APPLICATION NO.	FILING DATE	FIRST NAMED INVENTOR	ATTORNEY DOCKET NO.	CONFIRMATION NO.
10/791,778	03/04/2004	Chin Sung Ko	MR1197-610	4406
4586	7590 03/30/2006		EXAM	INER
ROSENBERG, KLEIN & LEE 3458 ELLICOTT CENTER DRIVE-SUITE 101 ELLICOTT CITY, MD 21043			HAWK, NOAH CHANDLER	
			ART UNIT	PAPER NUMBER
	,		3637	
		DATE MAILED: 03/30/2006

Application No.	Applicant(s)			
	10/791,778	KO, CHIN SUNG			
Office Action Summary	Examiner	Art Unit			
	Noah C. Hawk	3637			
The MAILING DATE of this communication a Period for Reply	appears on the cover sheet wit	th the correspondence address			
A SHORTENED STATUTORY PERIOD FOR REF WHICHEVER IS LONGER, FROM THE MAILING - Extensions of time may be available under the provisions of 37 CFR after SIX (6) MONTHS from the mailing date of this communication. - If NO period for reply is specified above, the maximum statutory perion. - Failure to reply within the set or extended period for reply will, by stat Any reply received by the Office later than three months after the may earned patent term adjustment. See 37 CFR 1.704(b).	DATE OF THIS COMMUNIC 1.136(a). In no event, however, may a re od will apply and will expire SIX (6) MONI tute, cause the applica

Katzberg '003, Figure 2

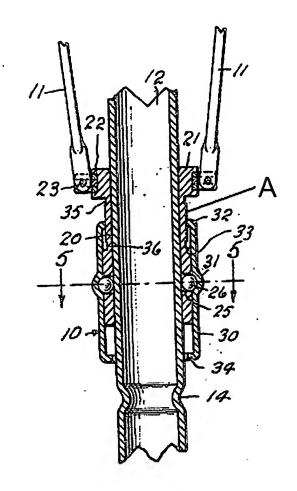
Regarding Claim 1, Katzberg discloses an engaging structure for an umbrella including a runner (encompassing 10 and 20) having a plurality of side apertures (25) formed on an inner circumference thereof, said runner having formed on an outer circumference thereof a positioning ring (A, Best seen in Katzberg, Figure 2, below), a plurality of balls (26) each received in a corresponding one of said apertures, a sleeve (30) slidably displaceable on said outer circumference of said runner, said sleeve including an upper opening (the opening at drawing line 5-5 in Figure 2) and an inner middle edge (the edge at drawing line 6-6 in Figure 3) having smaller diameter relative to a diameter of said upper opening, said sleeve having an inner low projective ring (32) formed on an inner circumference thereof so as to be selectively positioned on either of opposing sides of said positioning ring and a shaft (12) received in said inner circumference of said runner and having an annular concave portion (14) for receiving said balls therein, said balls being maintained in said annular concave portion by said middle edge of said sleeve when said projective ring is on a first one of said opposing sides of said positioning ring and said balls are received in said upper opening when said projective ring is on a second one of said opposing sides of said positioning ring.

b. Regarding Claim 2, Katzberg '003 discloses that the shaft is provided with several grooves (13, 14) spaced apart around the circumference thereof for engaging with said balls.
